**METROPOLITAN DEVELOPMENT COMMISSION
HEARING EXAMINER**

Case Number: 2025-CPL-862 / 2025-CVR-862 (Amended)
Address: 10401 and 10435 East Washington Street (*Approximate Addresses*)
Location: Warren Township, Council District #20
Petitioner: Washington Market Realty, LLC, % Sander Development Company, by Matt Yanda
Request: Approval of a Subdivision Plat, to be known as Replat of Block A and Lot 2 of Washington Market Commercial Subdivision, dividing 10.809 acres into one lot and one block.
Variance of Use and Development Standards of the Consolidated Zoning and Subdivision Ordinance to provide for a drive-through accessory use for a restaurant, within 600 feet of a proposed transit station (not permitted), and to provide for 31 parking spaces (maximum of 27 parking spaces permitted).
Waiver Requested: No
Current Land Use: Parking Lot
Staff Recommendations: Approval of Plat. Denial of Variances.
Staff Reviewer: Robert Uhlenhake, Senior Planner

SITE PLAN - AMENDED

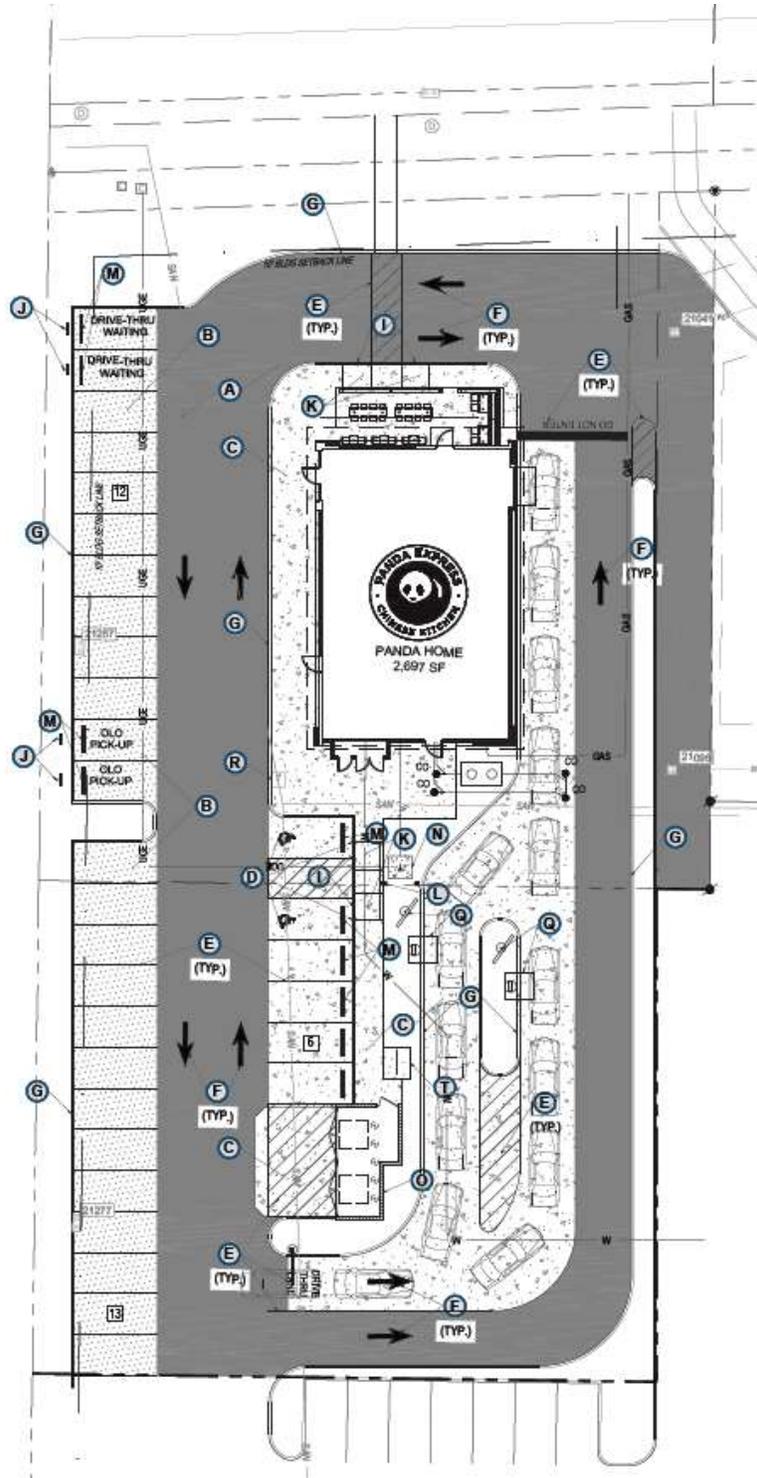
Table 742.207-2 in the Ordinance provides a list of prohibited uses and their limitations. For drive thru accessory uses, in this instance within 600 feet from a Transit Station, are prohibited except where they are located behind the building and all access is provided by alleys. The proposed use does not meet this exception as the drive through would be along the side of the proposed building and accessed would be provided by an internal drive.

For the amended request to provide for 31 parking spaces, even though the number of parking spaces may already exist on site, nothing prevents the developer from eliminating the excess parking spaces to accommodate the required 27 maximum parking spaces of the Ordinance as the proposed request will require new construction and development. The request to provide 31 parking spaces is a result of the petitioners specific design requirements, and not related to any limitations imposed by the site or the Ordinance.

For these reasons, staff is recommending **denial** of the Variance of Use and Development Standards request.
